Application No. SDP15-00004 (Site Development Permit)

STAFF REPORT

<u>Applications:</u>	Project No. PRJ14-00023 Site Development Permit: SDP15-00004
<u>Project name:</u>	Riva Townhomes
<u>Staff Contact:</u>	Amy Tarce, Senior Planner Development Services Department. 425-837-3097 amyt@issaquahwa.gov
<u>Applicant:</u>	Stacia Bloom Core Design 14711 NE 29 th Place, Ste. 101 Bellevue, WA 98007
<u>Owner:</u>	Gateway Smallwood LLC 14824 NE 95 th St. Redmond, WA 98052
<u>Request:</u>	Site Development Permit approval for 36 townhouses on approx. 8.39 acres. The site includes approximately 6.2 acres of critical areas, including a fish-bearing stream, and wetlands, and associated buffers for Tibbetts Creek and the wetlands, reducing the developable area to 2.19 acres. Site access is on Newport Way. A Shared Use Route (publicly-accessible multi-use trail) is provided along Newport Way and at the west boundary of the property. Private open spaces are distributed throughout the site. The majority of parking for residents are provided in individual garages, with small surface parking lots at two ends of the site.

Fig. 4. Newport Way Frontage Improvements for Riva

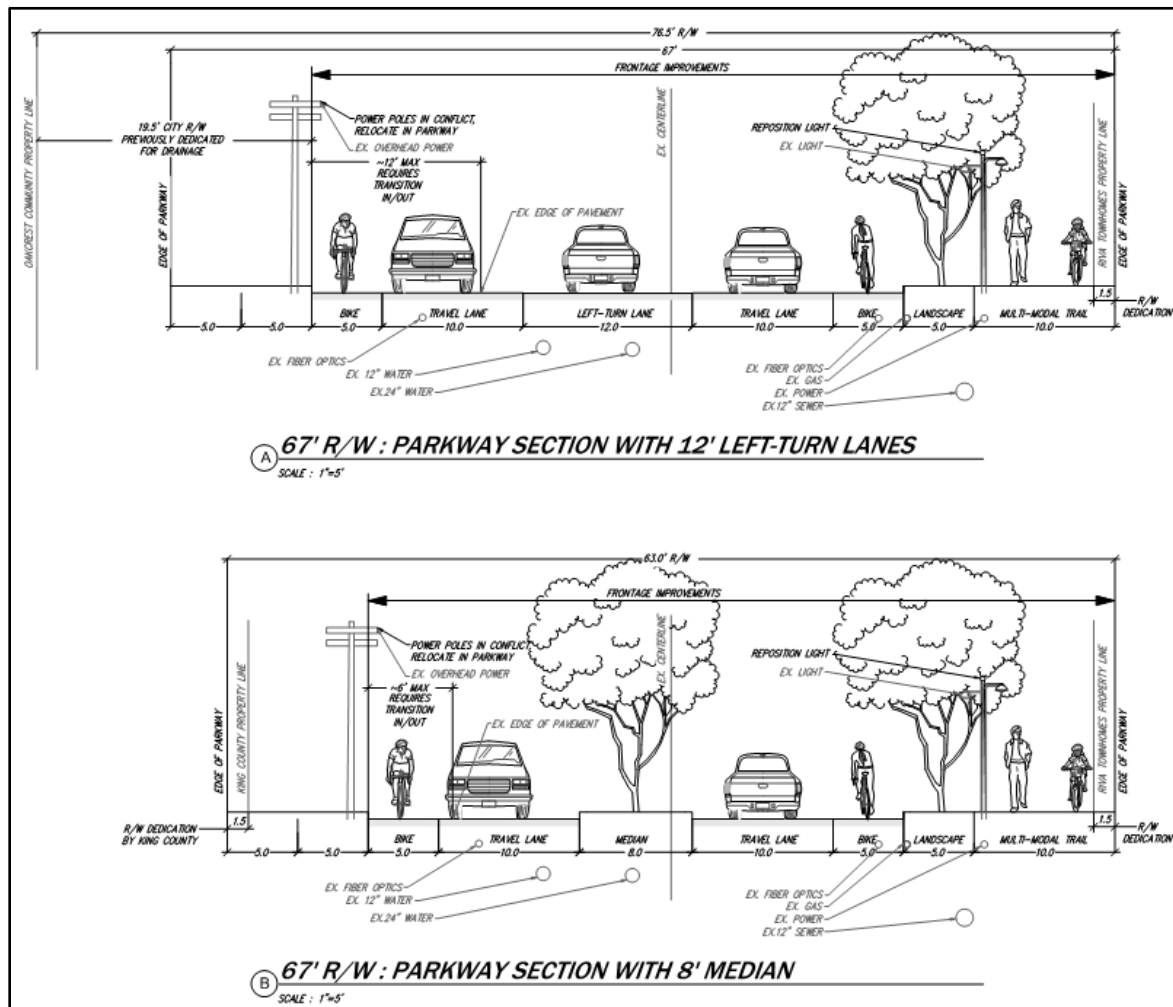
An Administrative Adjustment of the Parkway Standards for sections of Newport Way west of SR 900 is applied to the frontage improvements for the Riva project. The AAS is for the reduction of the travel lane from 11 feet to 10 feet. All other variations shown below are required improvements per the Transportation Impact Analysis for the project, and consistent with the reduction of the speed limit on Newport Way to 30 mph. Due to this adjustment of standards, the center line of Newport Way will shift west and the pavement will be expanded. The Applicant will be required to improve the full width of the travel lane on Newport Way, provide curbs and gutters at both sides of Newport Way and relocate the existing 5-foot bike lanes that are part of the Mountains-to-Sound Greenway regional bike trail. In effect, the existing shoulder on the west side of Newport Way will be taken up by the 5-foot

bike lane (see Sheet SDP-04, Offsite Improvements of Attachment 14). This shoulder is currently used as a temporary pedestrian access to the Cougar Mountain Regional Wildland Park (see Fig.4 below)

[Condition 2] **Newport Way frontage improvements shall include:**

- driveway curb cut raised to match the grade of the 10-foot sidewalk elevation and to extend 20 feet at a flat grade. The subgrade and paving shall meet the City's Street Standards T-06 specifications to accommodate heavy truck loads;**
- driveway width of 22', with a stripe to delineate two 11-foot wide lanes. A mountable curb is required to meet any fire turning radii. The maximum driveway slope shall be 15%;**
- Shared Use Trail traversing the driveway entrance to match the grade of the Shared Use Trail running parallel to Newport Way at the point of connection. Unobstructed maintenance access to the stormfilter vaults located adjacent to the Shared Use Route shall be provided;**

- d. Existing power poles on the south side of Newport Way relocated to meet the road side safety clear zone, as defined in the City of Issaquah Street Standards;

- e. Existing pedestrian-scale street lighting at east side of Newport Way relocated to the new landscape planter strip and meet ADA clearance requirements and Chapter 17 light level requirements;

Fig. 5 Primary Through Block Passages proposed

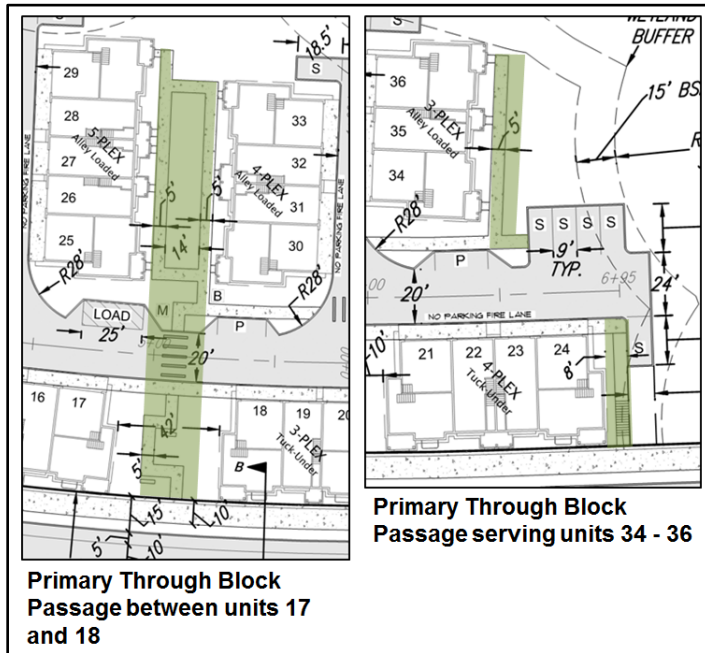
A Primary Through Block Passage between Buildings 17 and 18 shows a 5-foot wide walkway that meanders to adapt to the site grade, and continues to the rear half of the site as two sidewalks serving primary pedestrian access to Buildings 25 to 33 (See Fig. 5). For the section of the Primary Through Block Passage serving the buildings 25 to 33, the split sidewalk configuration is appropriate even though it does not meet the standards because the location of the two 5-foot sidewalks provides convenient access to the building entries. An Administrative Adjustment of Standards is required to provide 2 5-foot wide sidewalks instead of the CIDDs prescribed 10-foot sidewalk. Units 34 to 36 are also served by a Primary Through Block Passage. The proposed sidewalk width is 5 feet and does not meet the standard 10 feet required. This Through Block Passage is disconnected from Newport Way (see Section 12.2.C discussion on Visual Cues)

A Secondary Through Block Passage is provided between units 5 and 6, where a 20-foot public easement for the Anti-Aircraft Creek culvert is provided. The 5-foot sidewalk meanders to work with the existing grade change of 10 feet from Newport Way to the alley in the interior of the lot (see Fig. 6)

[Condition 3] ***The walkway of the primary through block passage between buildings 17 and 18, between Newport Way and the alley, shall be 10 feet wide.***

[Condition 4] ***A 10-foot wide sidewalk shall be provided to serve buildings 34 to 36 and the communal open space/nature-based play area.***

Fig. 7, Shared Use Routes per CIDDs Fig. 7B

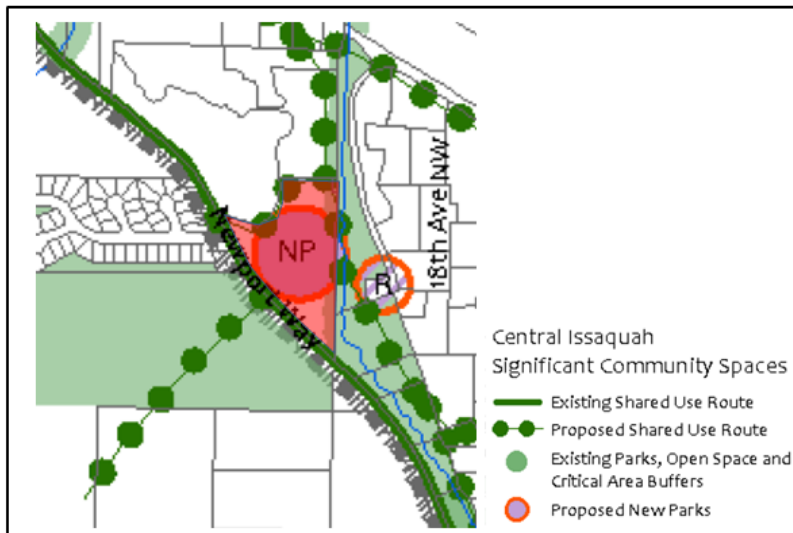
A new Shared Use Route is also required along the north boundary of the property, as shown in Fig. 7, *Shared Use Routes per CIDDs Fig. 7B*. The Applicant has provided a site plan showing the general location of a 10-foot wide Shared Use Trail (see Attachment 6). Additional discussion of Shared Use Route is found in the Community Spaces section of this staff report.

[Condition 9] ***The new Shared Use Route in the Riva property shall be extended to run along the northern property line as shown in CIDDS Figure 7B, Central Issaquah Significant Community Space, and shall connect from the Shared Use Route on the east side of Newport Way and terminate at the east property line, unless the City owns the Tibbetts Creek wetland immediately north of the Riva property or the Applicant negotiates an easement with that property's owner. Then the Route shall connect to the proposed bridge over Tibbetts Creek associated with the Gateway Apartments project (SDP15-00002), instead of turning east when it reaches the northwest corner of the project site.***

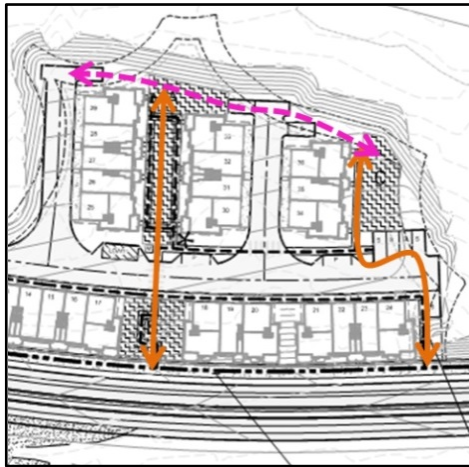
Surface parking proposed next to open spaces and in the building setback line cuts off the open spaces from the pedestrian circulation and residential units (see sheet L2.06). 1) The single parking space next to unit 24 could be better used as a walkway to connect the exterior stairs at Newport Way to Open Space C along the edge of the stream buffer.

[Condition 16] ***Remove single surface parking space next to unit 24 and connect the exterior stairs to Open Space C and primary through block passage serving units 34 to 36.***

Fig. 16. Buildings that require special treatment at corners

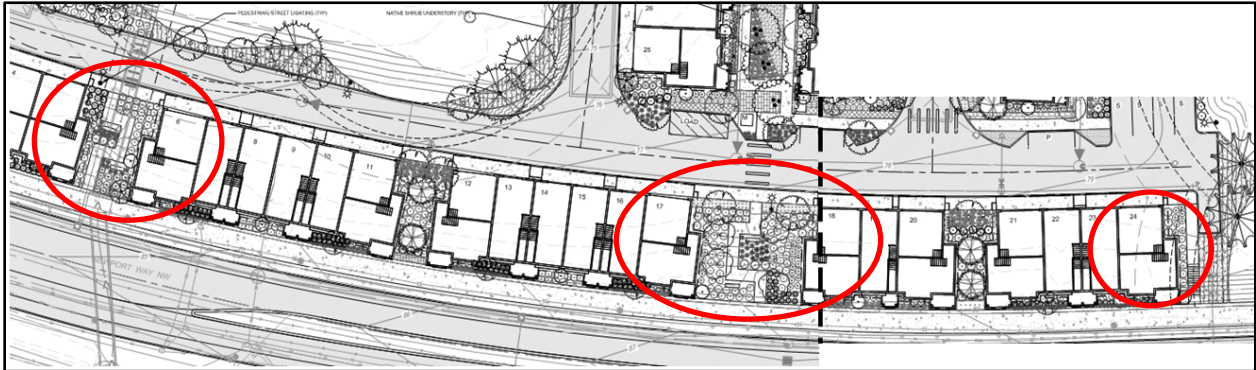
CIDDs 14.3.A.9 require special treatment of building corners when the building is visible from two intersecting Circulation Facilities. This standard would apply to units 9, 10, 17, 18 and 25, where Through Block Passages

intersect Newport Way. Based on the elevations provided, which are all typical elevations, no special corner treatments have been proposed.

[Condition 23] *Provide additional architectural details to enhance the more visible corners of units along Newport Way that frame the required Through Block Passages.*
